VILLAGES AT STERLING RANCH

CONSTRUCTION PLANS

NOVEMBER 2024

V1_Construction Drawings (Plans-Profiles).pdf Markup Summary

VILLAGES AT STERLING RANCH
STREET IMPROVEMENT PLANS
ST LOUIS ROAD & MILWAUKEE HEIGHTS

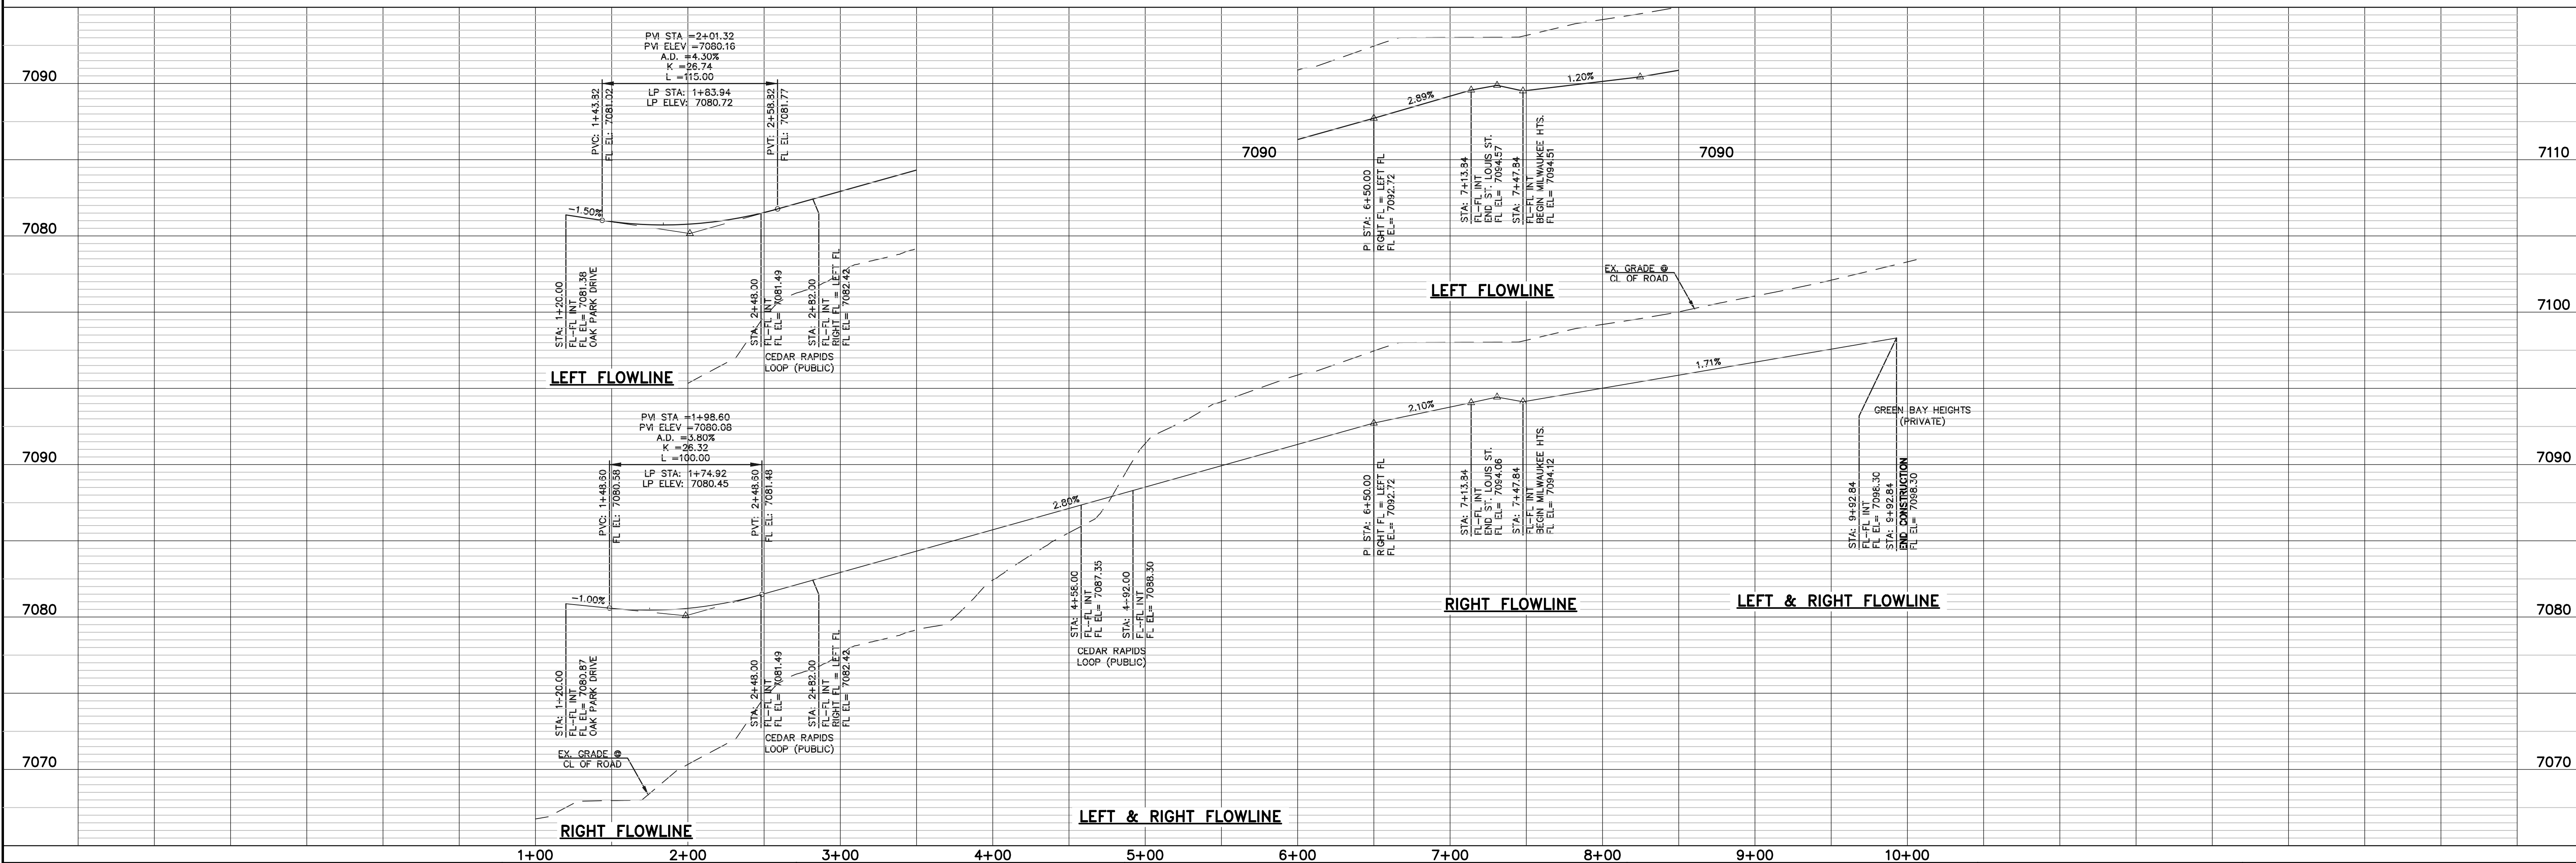
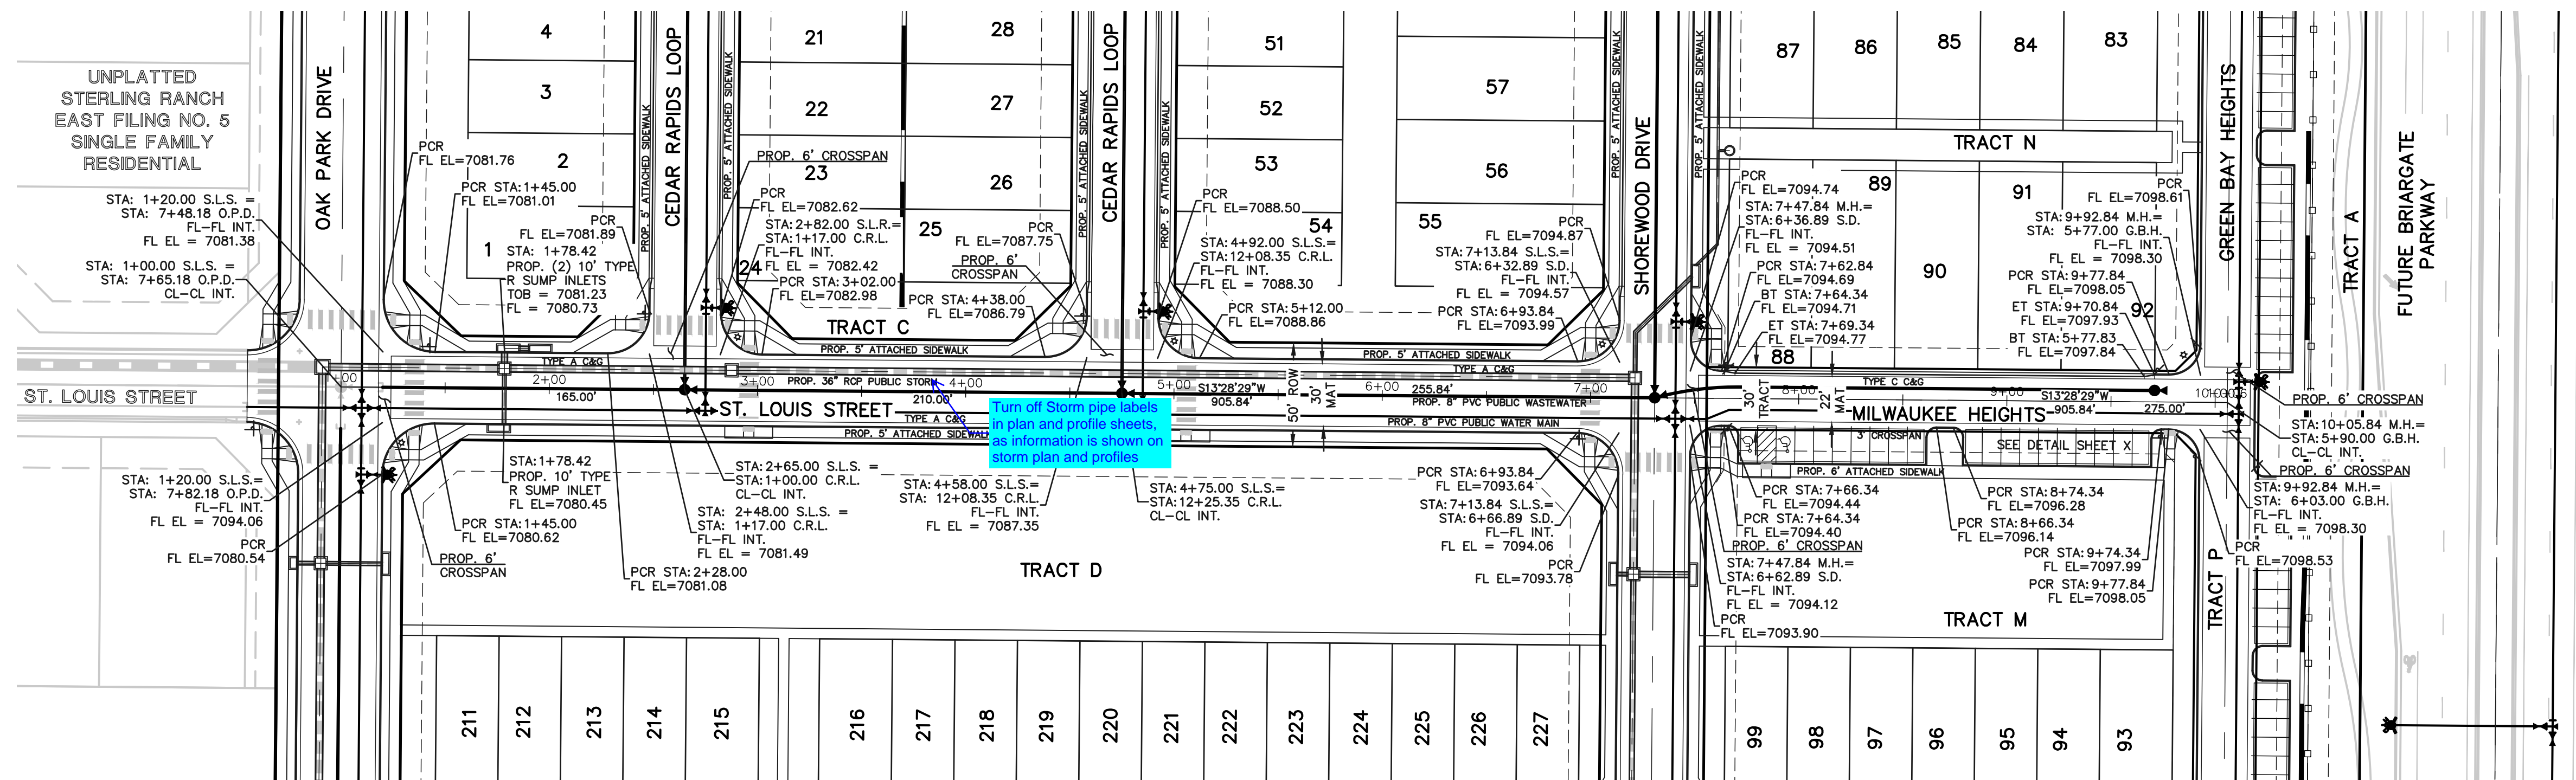
Turn of Storm pipe labels
in plan and profiles sheets,
as information is shown on
storm plan and profiles

STREET IMPROVEMENT PLANS
 SIGNAGE & STRIPING PLAN

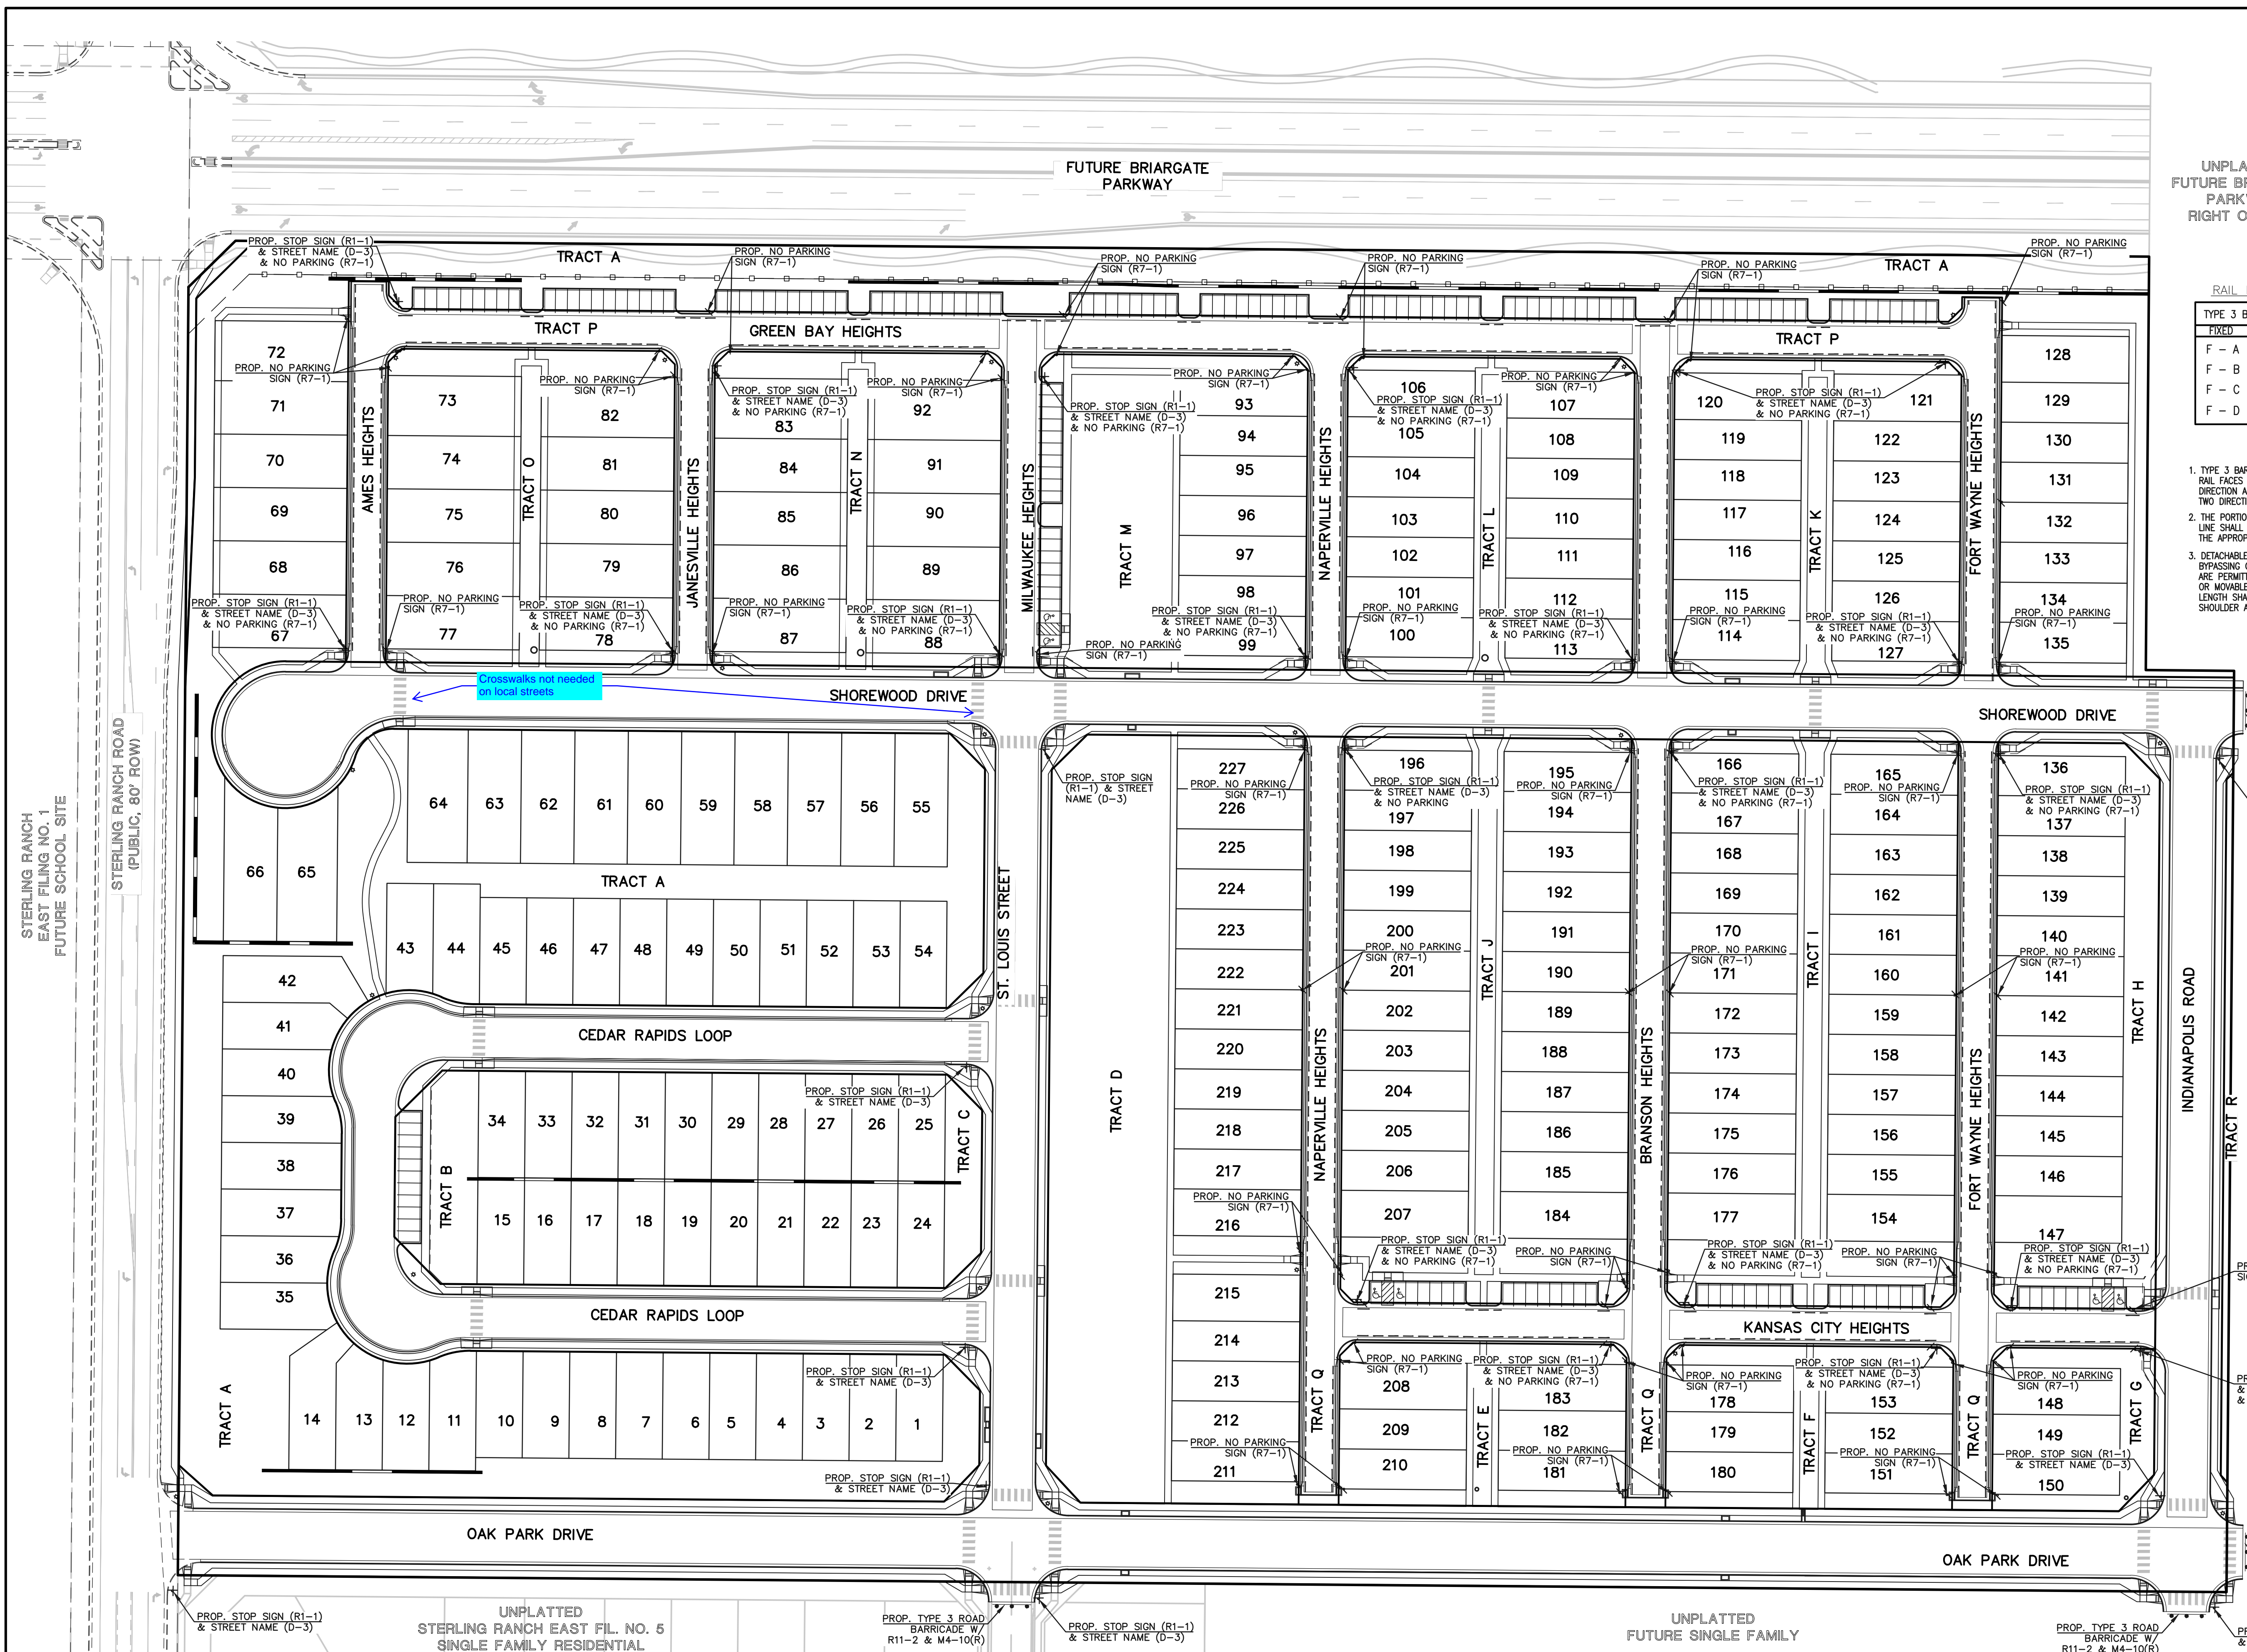
Include CDOT detail showing sign placement

Are 15 mph signs being posted, or will it be a generic sign prior to entering private roads?
